FIELD CHANGE ORDERS

EARTHWORK REMEDIAL ACTION
RICHARDSON HILL ROAD LANDFILL SUPERFUND SITE
SIDNEY, NEW YORK

FIELD CHANGE FORM # 001

**Figure 1. MODEL RESULTS FOR 3-SUMP EVALUATION
(cross-section across trench)**

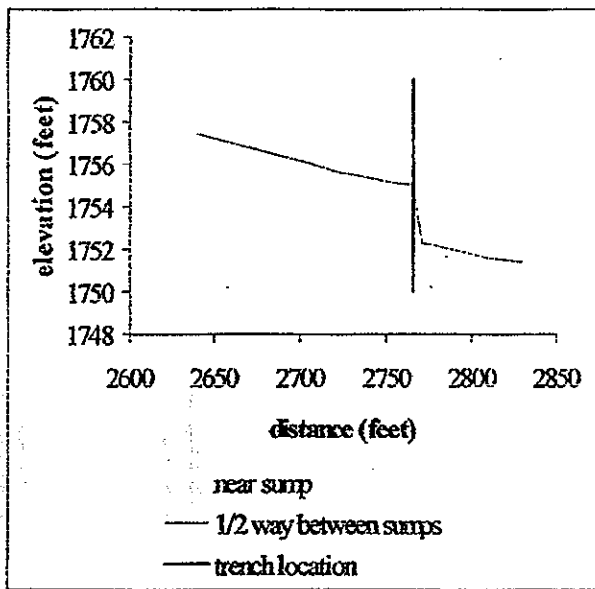
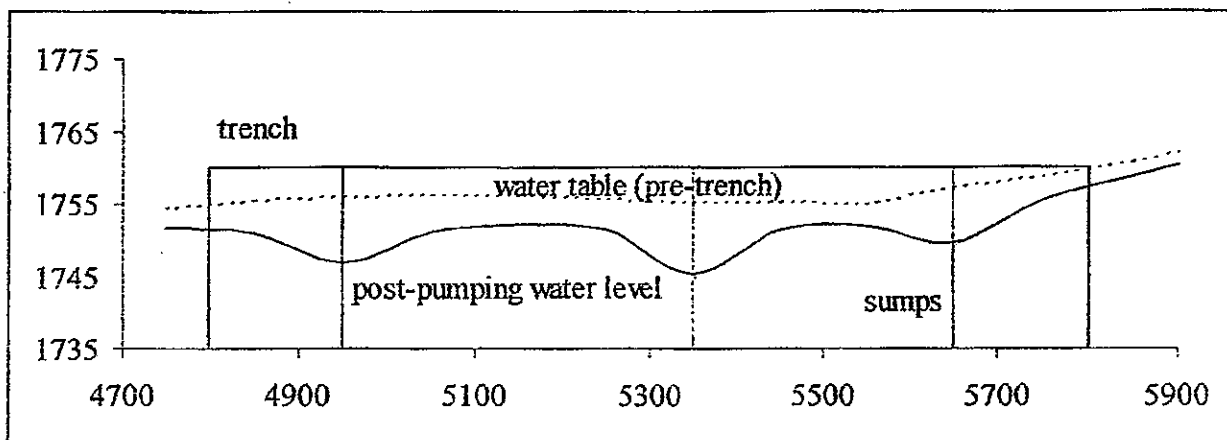
The model calculated a drawdown of about 6 feet at the sumps and 2 feet halfway between the sumps, (see Figures 1 and 2). I redid the particle-tracking analysis, which also indicated full capture by the trench. I also ran a simulation with 5 sumps (see Figure 3), which calculated a more "even" distribution of drawdown along the trench, similar to what would be observed with a horizontal drain.

Based on these simulations, the three-sump trench would provide adequate capture, but the 5-sump trench would offer more flexibility in trench operation and a higher safety factor, especially during periods of increased recharge.

Figure 2 - Typical Cover Section Using GDC

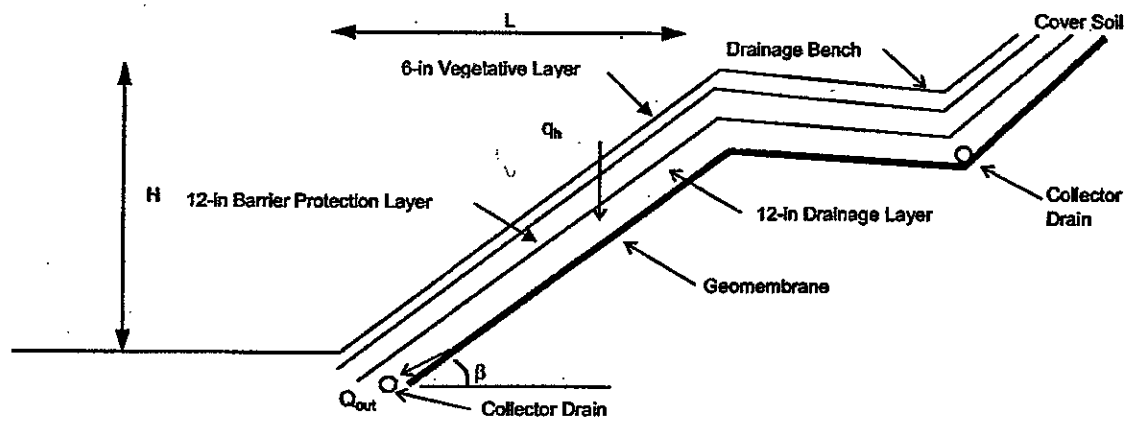
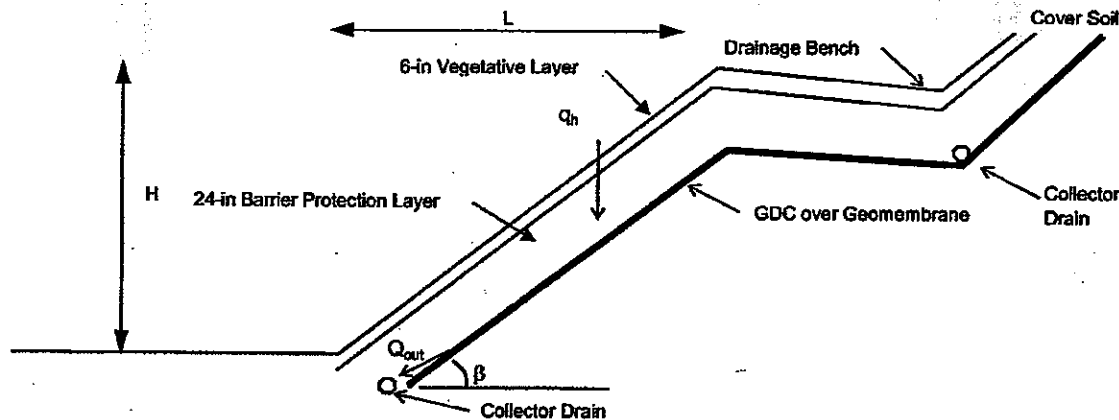
2b. Install a geosynthetic drainage composite (GDC) and 24" of modified barrier protection soil in lieu of the 12" drainage sand and 12" of specified barrier protection soil. The GDC material shall meet the requirements specified below:

If GDC is selected for the drainage layer, the following revised drainage system design should be utilized (top to bottom):

Field Change Notice
FSK-2 Rev 1 10/20/04

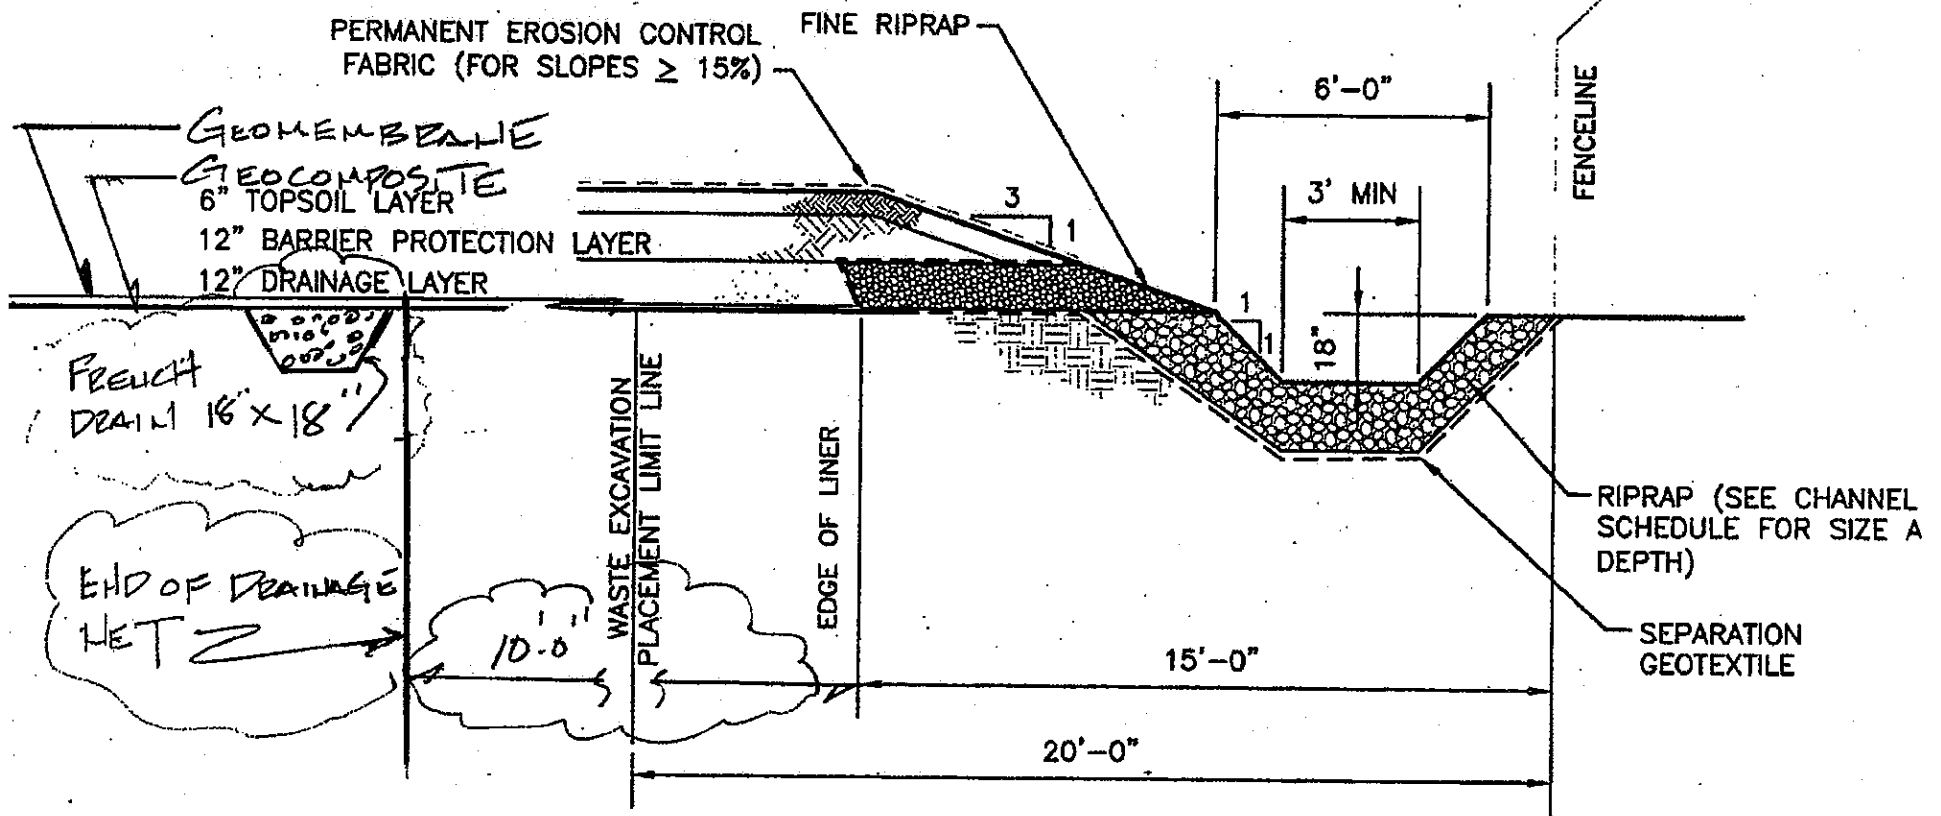
Terminate the end of the Geocomposite drainage net ten feet from the end of the liner on the north and south ends of the landfill per the attached field sketch FSK-2 Rev 1. The purpose of this modification is to eliminate the possibility of leakage from under the liner at the ends of the horizontal drainage swales.

TOE ANCHOR DETAIL (NTS)

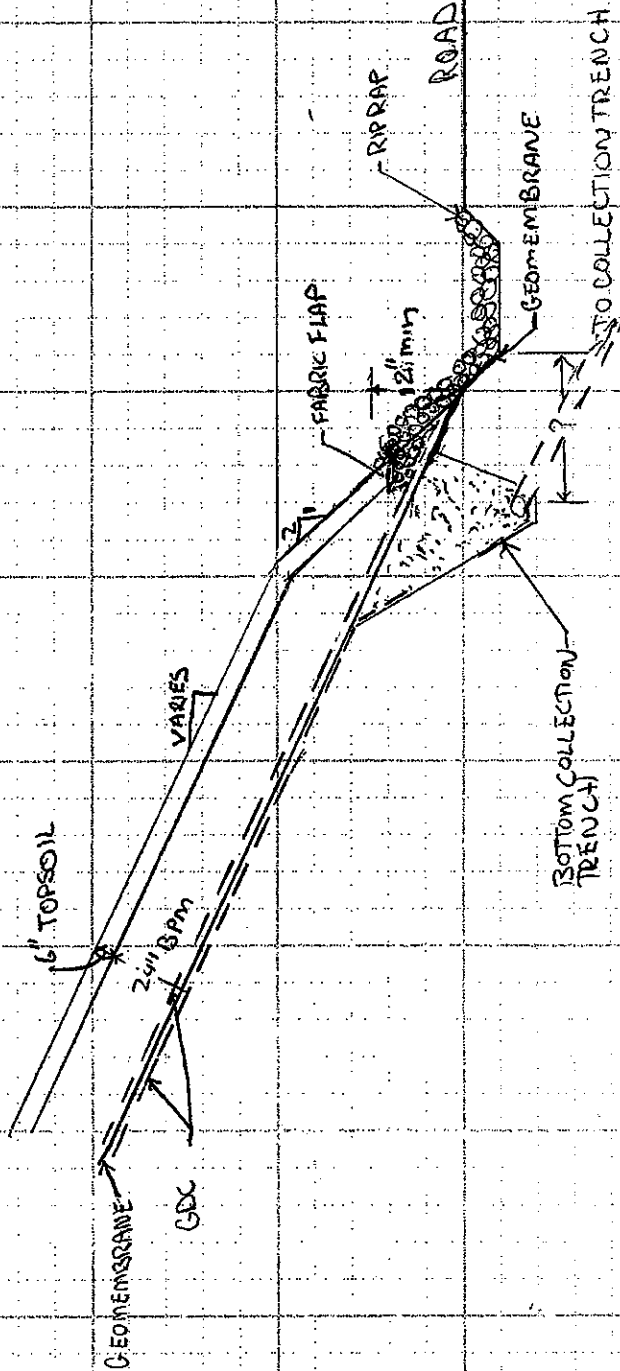
Attached is a sketch to clarify Detail D (Toe Detail) on Drawing C-10 based on the as-built configuration slopes at the toe landfill. I talked to Dan about it and he seems on board with it and doesn't see any problem with it. He would still like to take a quick look at the sketch. If you have any questions please let me know.

- 1) ANCHOR GEOMEMBRANE UNDER RIP-RAP
- 2) SEPARATE TOE FABRIC WHERE GDC TIES INTO RIP-RAP TO ALLOW FREE FLOW FROM GEOMET TO SWALE
- 3) INSTALL PERMANENT EROSION CONTROL FABRIC FOR SLOPES $\geq 15\%$
- 4) SWALE DIMENSIONS AND COLLECTION TRENCH DIMENSIONS AS SHOWN ON DETAIL D ON C-10.

**LATERAL DRAIN WITH
GEOCOMPOSITE DRAINAGE LAYER**

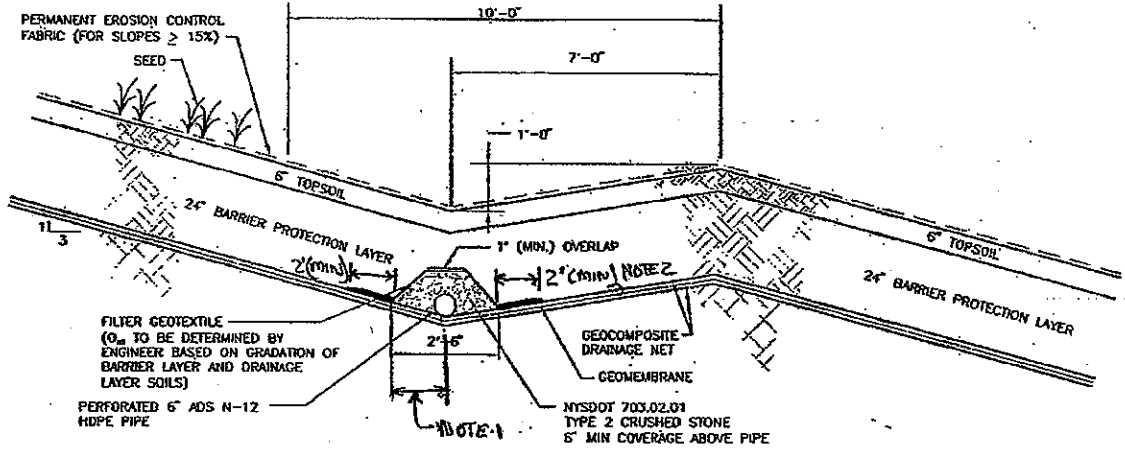
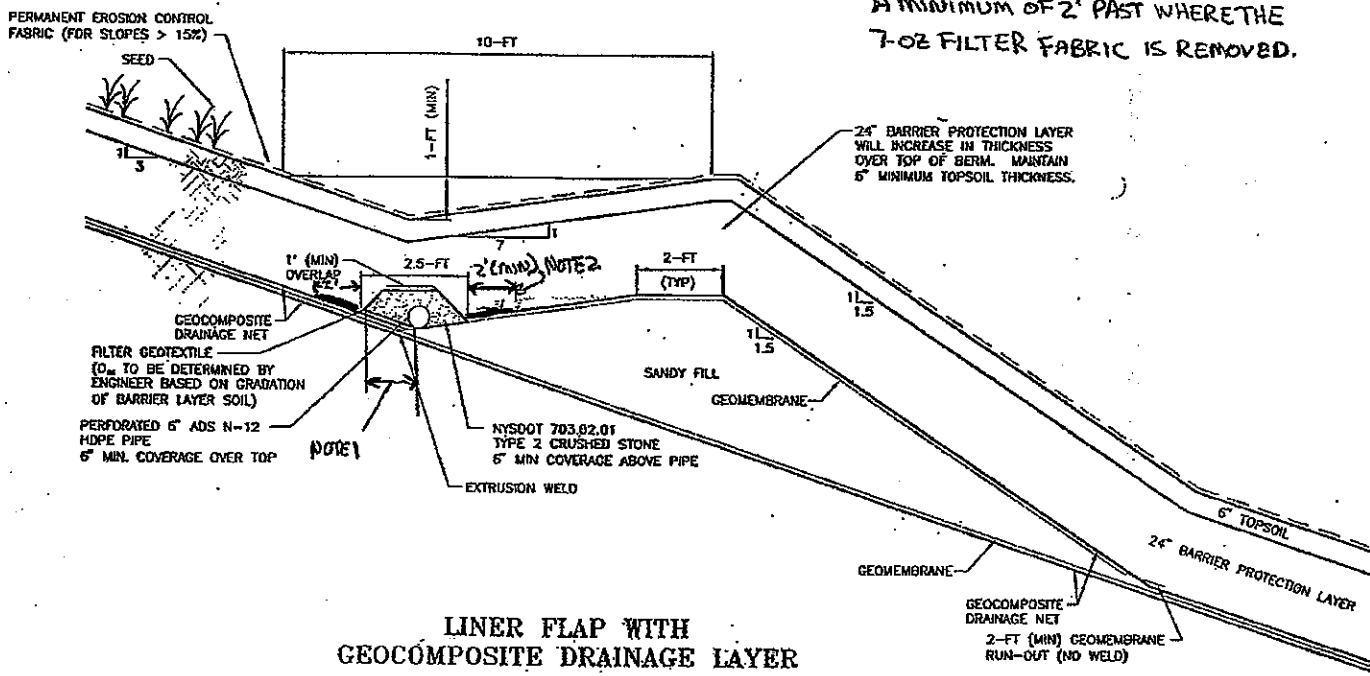
- To promote free flow at the discharge point of the GDC, remove sufficient 7-oz fabric to allow the geonet to be in contact with the perforated 6" ADS N-12 HDPE Pipe.
- To prevent the migration of fines in the geonet place sufficient filter geotextile to separate the BPM from the Type 2 Crushed stone. The filter geotextile shall extent a minimum of 2 feet past where the 7-oz fabric is removed or peeled back.

1. 7-02 FILTER FABRIC SHALL BE REMOVED TO ALLOW CONTACT BETWEEN THE GEONET AND 6" ADS N-12 HDPE PIPE
2. THE FILTER GEOTEXTILE SHALL EXTEND A MINIMUM OF 2' PAST WHERE THE 7-02 FILTER FABRIC IS REMOVED.
